Ref: BHE/PW/PUR/KTI-STG/1114/Corrigendum-03

Sub: Corrigendum-03: Issue of Clarifications

JOB: RECEIPT OF MATERIALS FROM STORES, TRANSPORTATION TO SITE OF WORK, ERECTION, TESTING, COMMISSIONING AND HANDING OVER OF STEAM TURBINE, TURBO-GENERATOR, ~~CONDENSER~~, TG INTEGRAL PIPING, HP & LP HEATERS, ~~DEAERATOR~~, WITH ASSOCIATED EQUIPMENTS/TANKS/VESSELS, ~~FST & DEAERATOR~~, LP BYPASS SYSTEM WITH ASSOCIATED PLATFORM, ~~POWER CYCLE PUMPS & ASSOCIATED AUXILIARIES B.F. VALVES ETC~~, BOUGHT OUT ITEMS, PEM PACKAGES ETC IN UNIT 1 & 2 AT (2x150 MW) OPGS POWER GUJARAT PVT. LTD. DIST. – KUTCHH GUJARAT.

Tender Specification Number: BHE/PW/PUR/KTI-STG/1114

TITLE	DRAWING NO.	REV.
INTER CONNECTING PIPING	1-112-09-62001.04

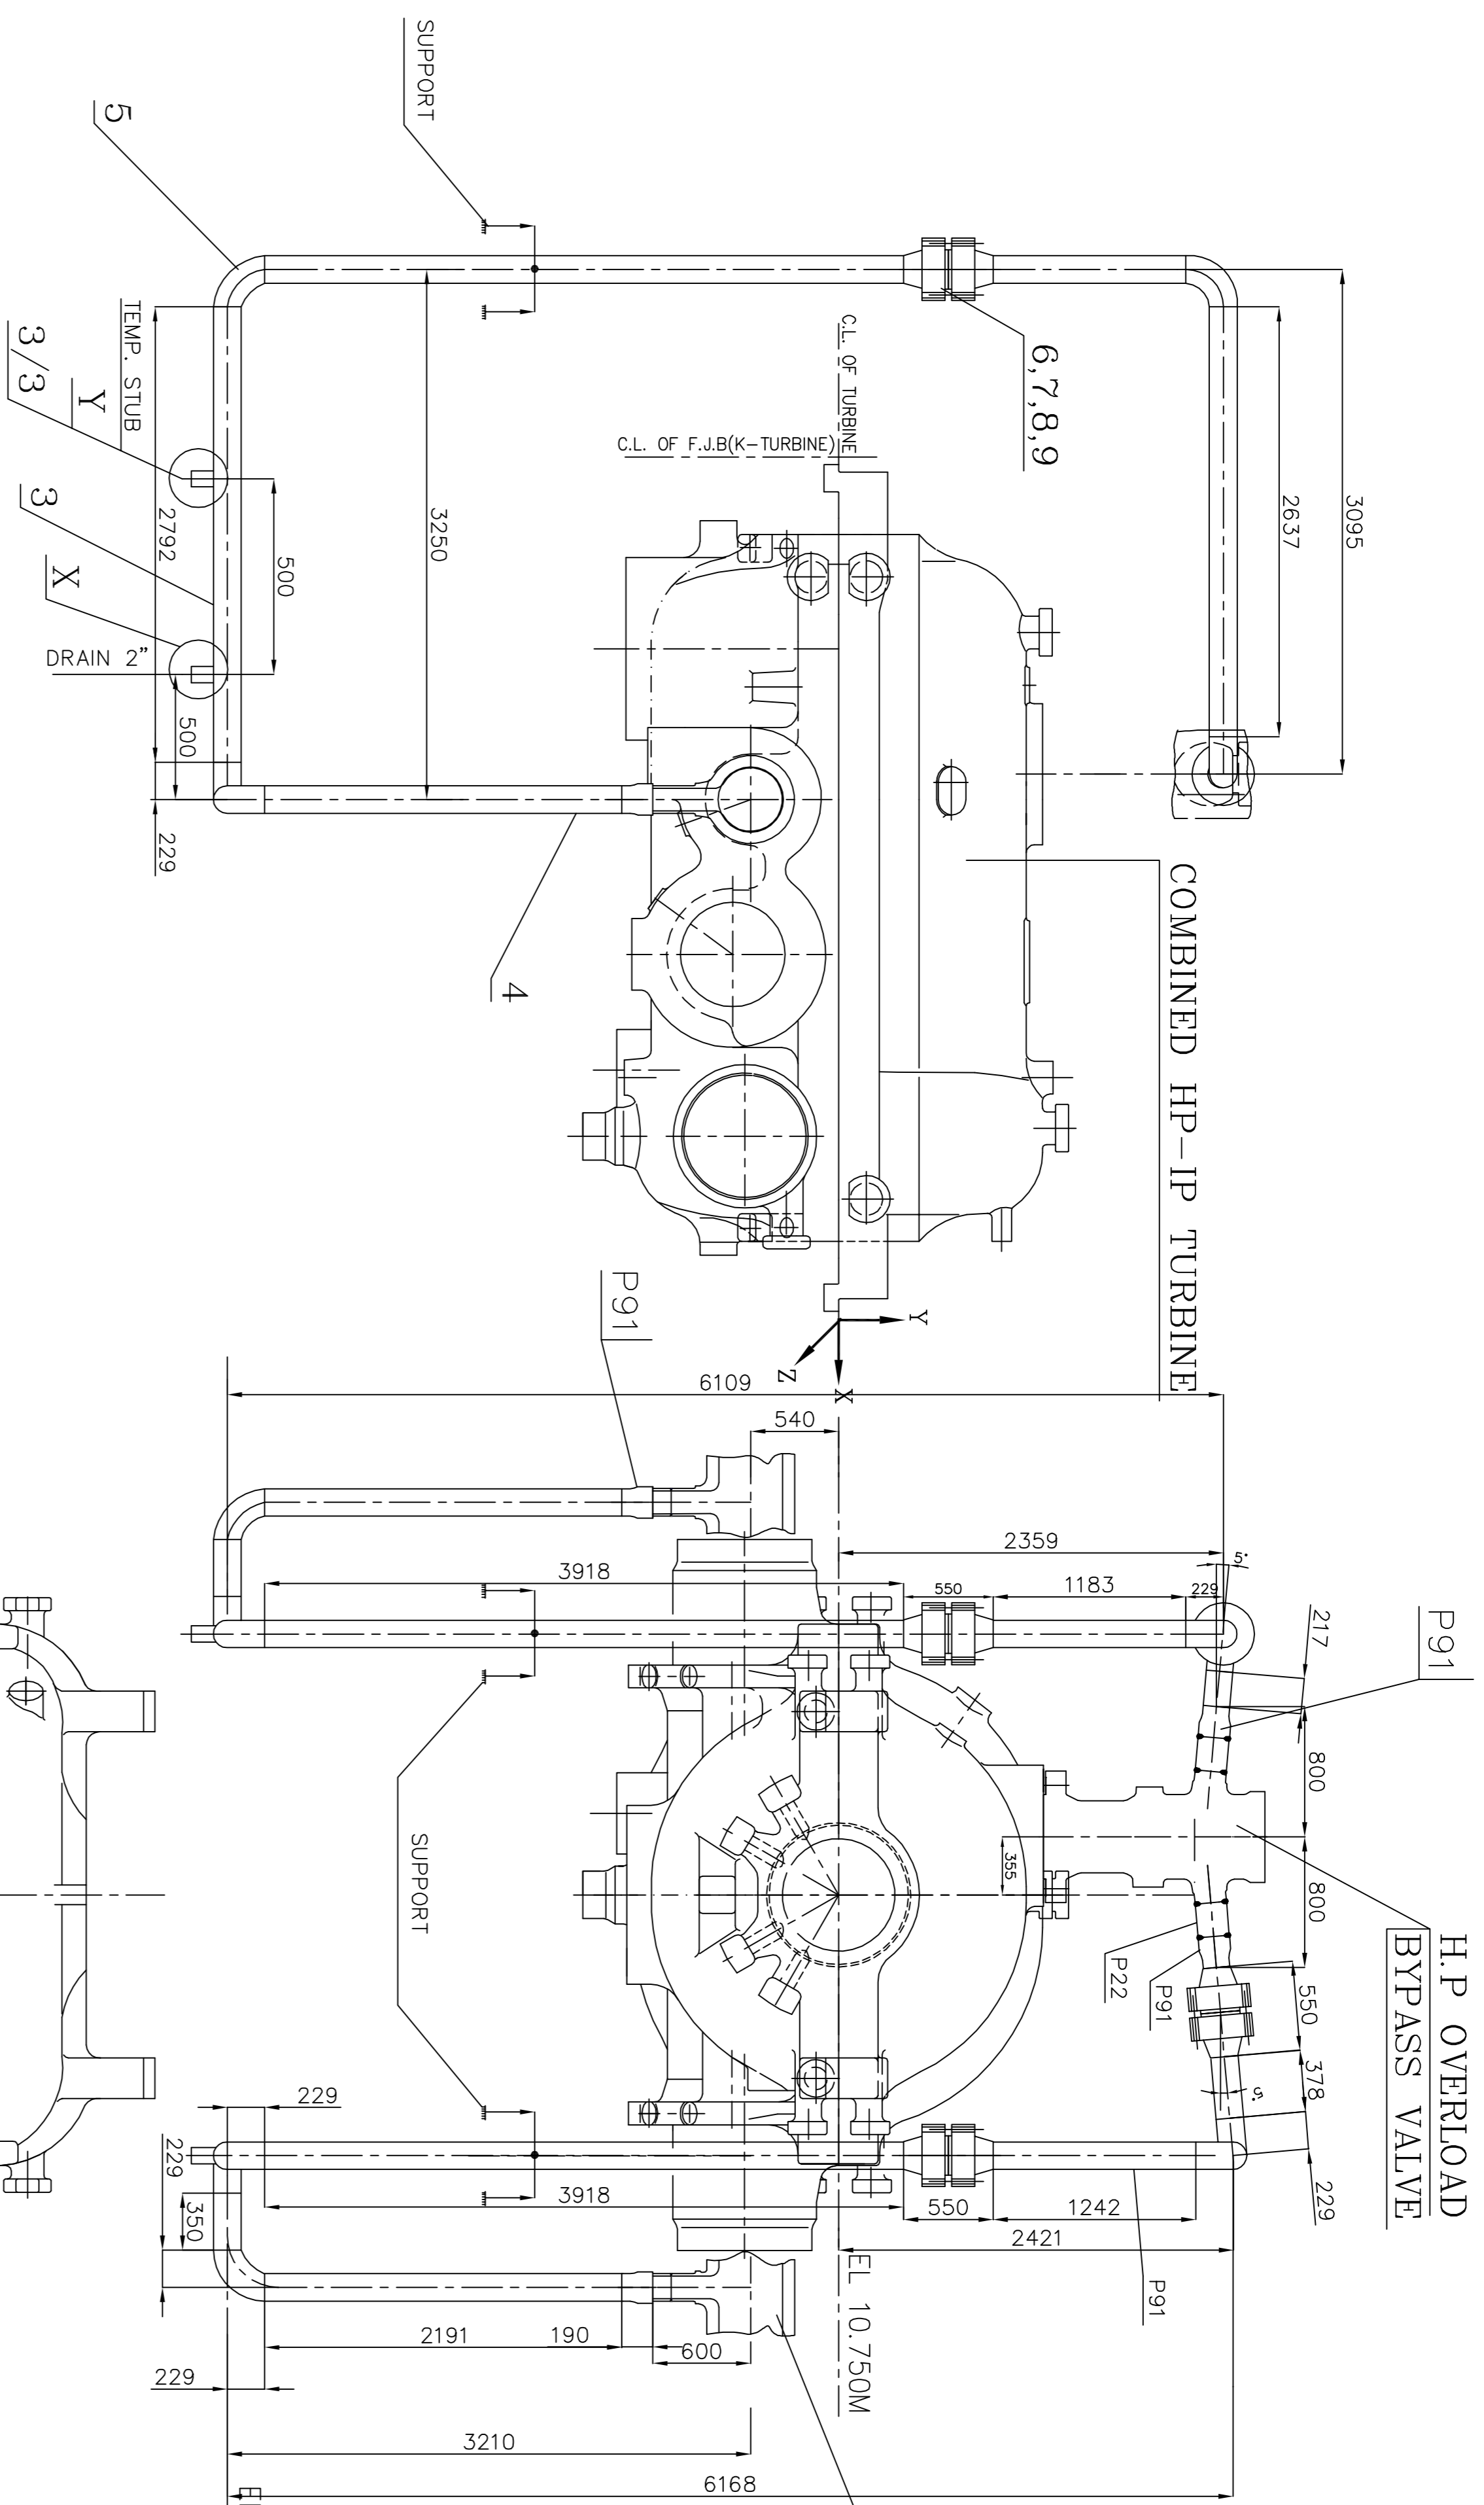
QUERY 02: Refer Clause No 9.11 of Volume IA ‘Technical conditions of Contract’: As per the clause, interconnecting piping (P-91) between HP Valve & HP Overload valves is in the scope of contractor. Please confirm the weight of P-91 Piping or total Length and number of joints given are for one unit or both units.

Please Refer the ‘Assembly Drawing of HP Valve and HP Overload Valve’ attached herewith.
